## 5.02. REQUEST FOR PERMISSIBLE CHANGE - RECONFIGURING A LOT (1 INTO 5 LOTS) 1L OASIS DRIVE, WONGA BEACH, FLORO PTY LTD

**PROPOSAL** Request for a Permissible Change - Reconfiguring a Lot (1 Lot into 5 Lots)

**PROPERTY** Lot 1 on SP259953

Drawing No	Issue
30728-PP01	A

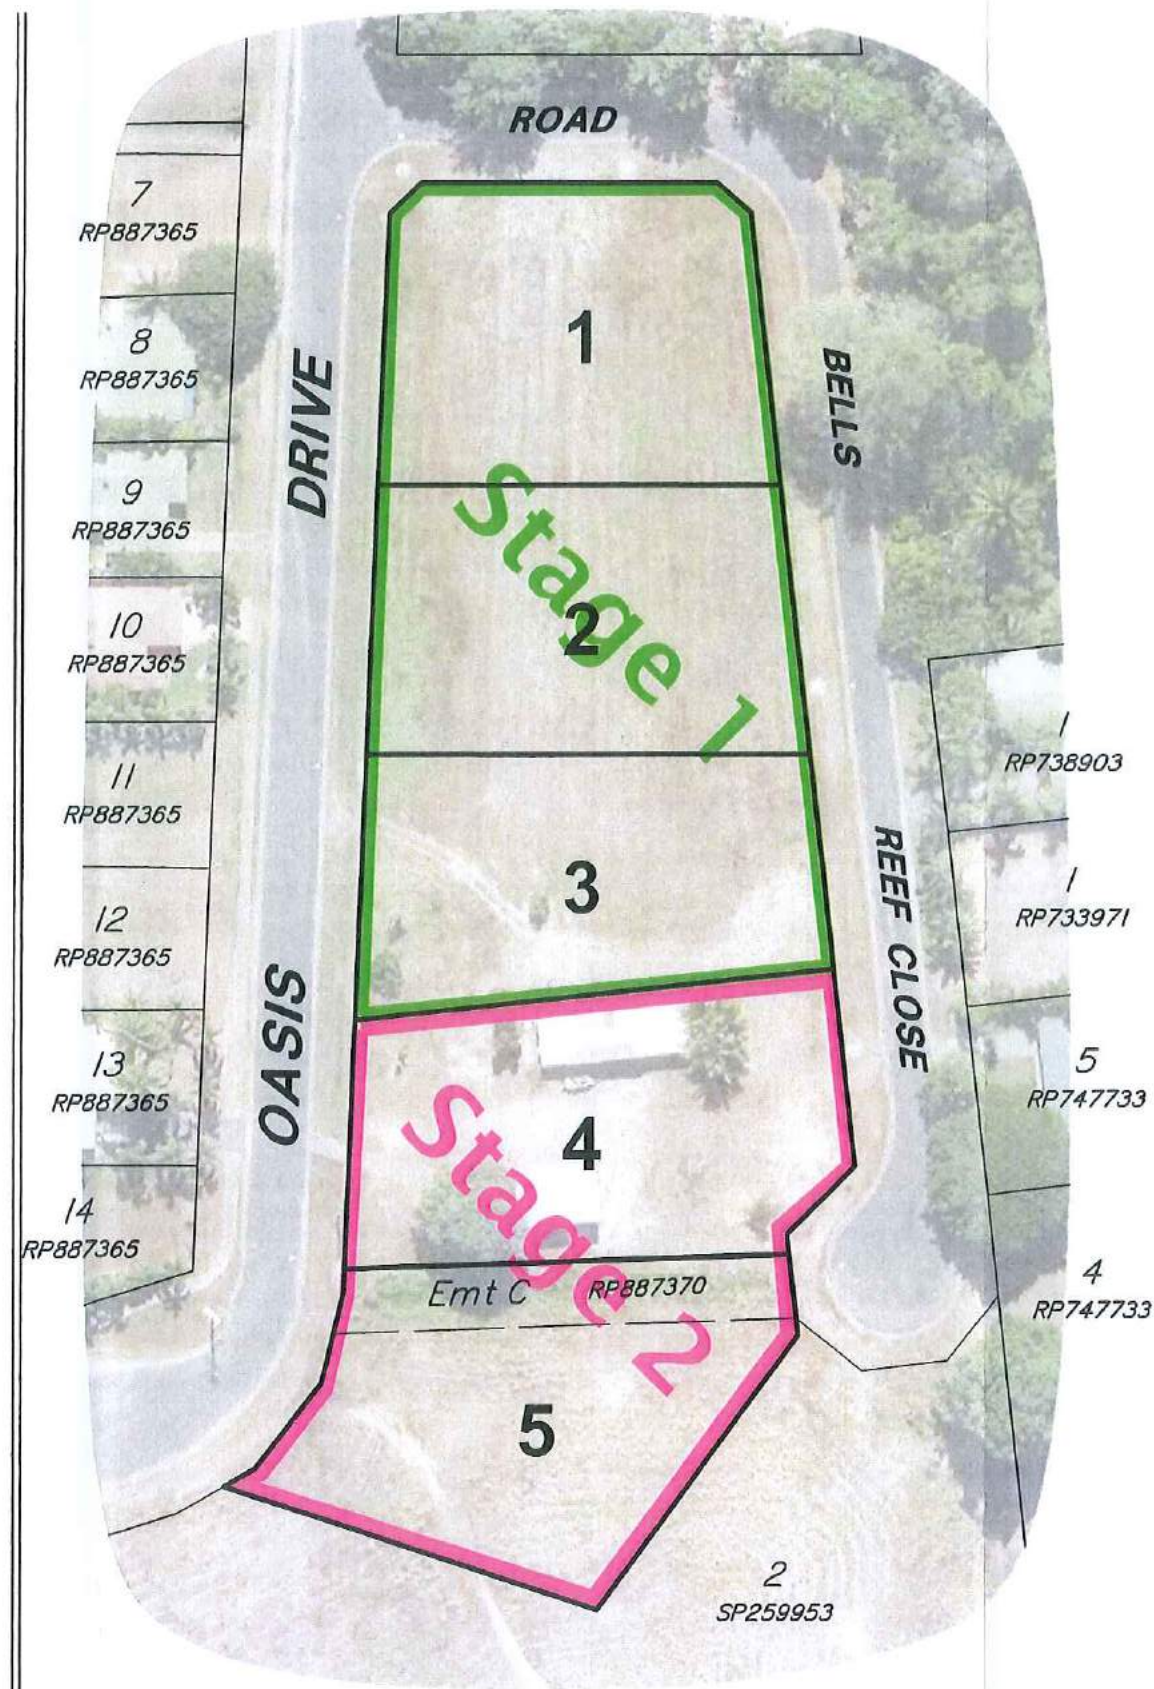
Condition 1 relates to the layout of the site. The applicant wishes to undertake the development in two (2) stages as depicted on proposal 30728-PP01A.

**Comment:** The only concern raised with the staging proposal is that it will create a balance lot (being Stage 2) that could be disposed of separately to Stage 1. Given that the lots are subject to potential storm-tide inundation, the balance lot will need to have the nominated fill in place within either proposed Lot 4 or 5 prior to Council being required to issue a certificate of compliance for Stage 1. Conditions 1 and 4 are recommended to be amended accordingly.

<b>Drawing or Document</b>	<b>Reference</b>	<b>Date</b>
<b>Plan of Proposed Lots / <u>Staging</u></b>	<b>CNS Drawing 30728-PP01 Issue <u>A</u></b>	<b>As submitted to Council on <u>30 March 2016</u> 1-August 2014</b>
<b>Filling and Drainage Plan</b>	<b>PDR Engineers drawing 14810 – SK01 Revision A dated February 2015 and to be amended by the conditions of the approval</b>	<b>To be determined.</b>

14/810 - SK01

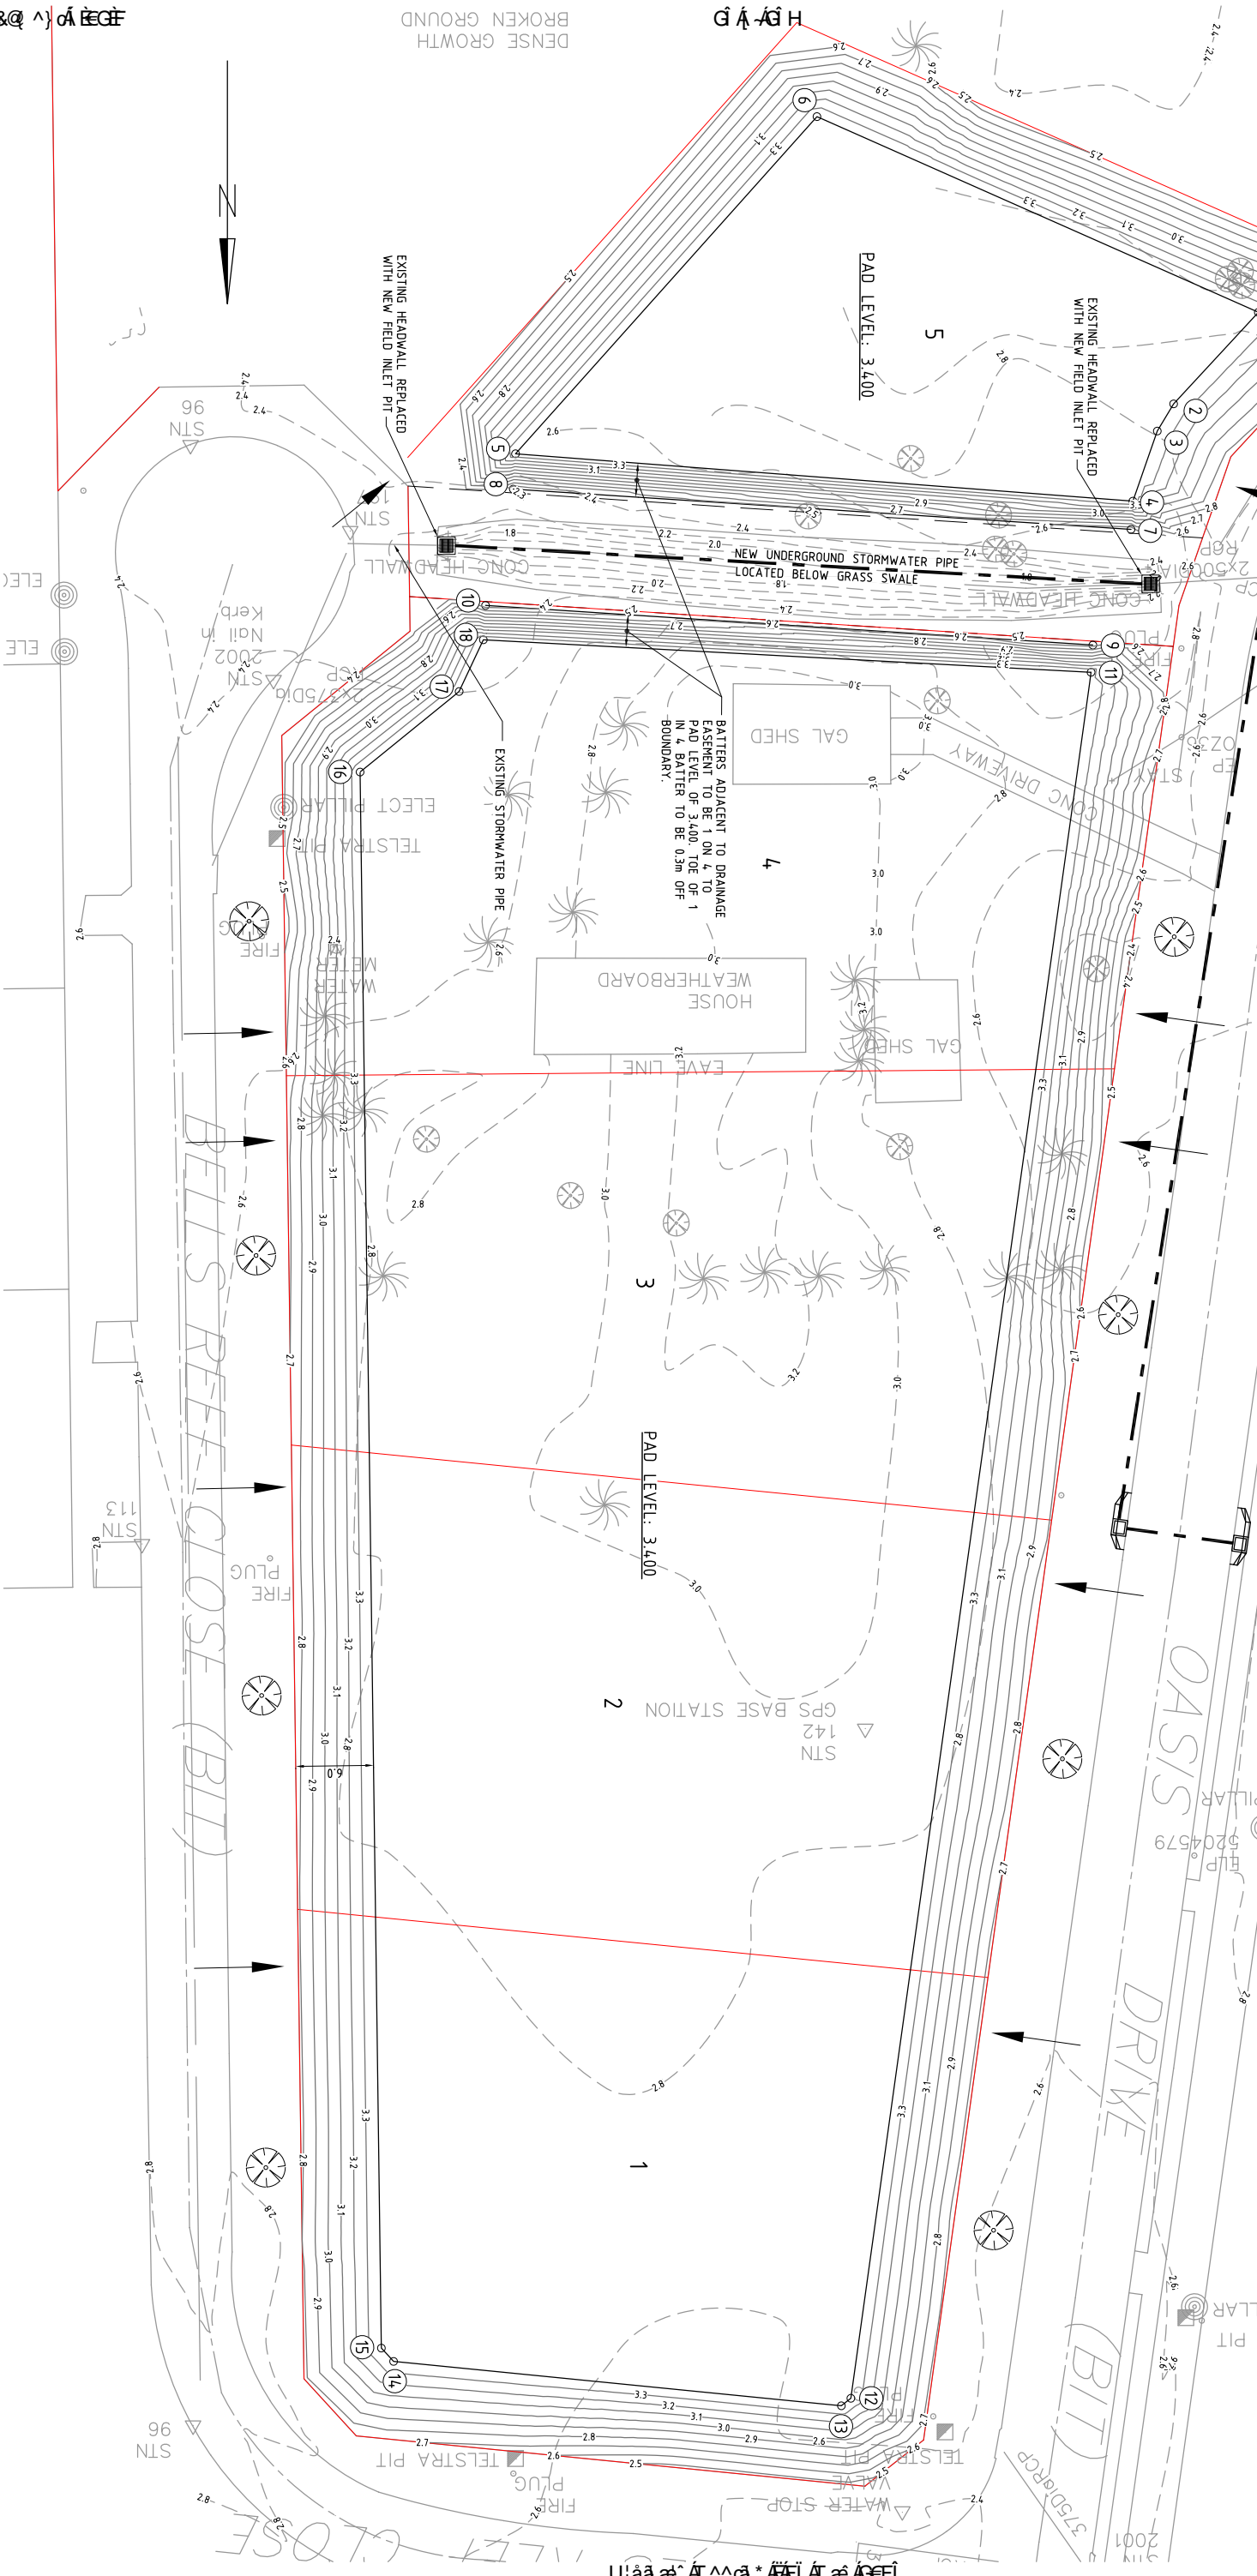
3. Access for Proposed Lot 1 must only be south of the proposed street trees to either Oasis Drive or Bells Reef Close as detailed on PDR Engineers drawing 14810 – Sk01 Revision A dated February 2015.

4. The lot fill design is to be generally in accordance with PDR Filling and Drainage plan 14810 – SK01 Revision A dated February 2015 subject to:
  - a. Setback of fill areas a minimum of 6m from the property boundary from all roads.

- b. A minimum fill pad of 1000m<sup>2</sup> must be provided for each lot.
  - c. Fill lots in compliance with condition 9 below;
  - d. The fill pads for proposed Lots 3 and 5 are to be extended to the southern boundary of each lot and retained;

- e. Appropriate protection is to be provided to prevent non authorised vehicles from entering the drainage easement including at a minimum, Barrier Kerbing. The applicant is to assess the need for additional barriers and or landscaping in these areas;

- f. Delete the vehicle access from Bells Reef Close for proposed lot 5; and
  - g. A filling pad will be required within either proposed Lot 4 or 5 in Stage 2, that conforms with these conditions of approval, in association with the development of Stage 1; and

- 9. The concept for excavation and earthworks as detailed on PDR Engineers Fill and Drainage Plan Drawing 14810 – SK01 Revision A dated February 2015 is generally approved subject to compliance with the on-site disposal and drainage conditions and subject to the following amendments:**
  - a. The earthworks fill zones are to be continuous to the southern boundaries of Lots 3 and 5;**
  - b. For lots 1, 2, 3 and 5 the nominated fill level of 3.4m is to be increased to 4.04m AHD level unless otherwise approved by Council. Any reduction below 4.04m AHD must be supported by a further study, to the satisfaction of Council, to a lower level than 4.04 but no lower than 3.54m AHD. Any reduction below 4.04m AHD must utilise at least a 0.3 Sea Level Rise (SLR) and increase in intensity of cyclone action.**
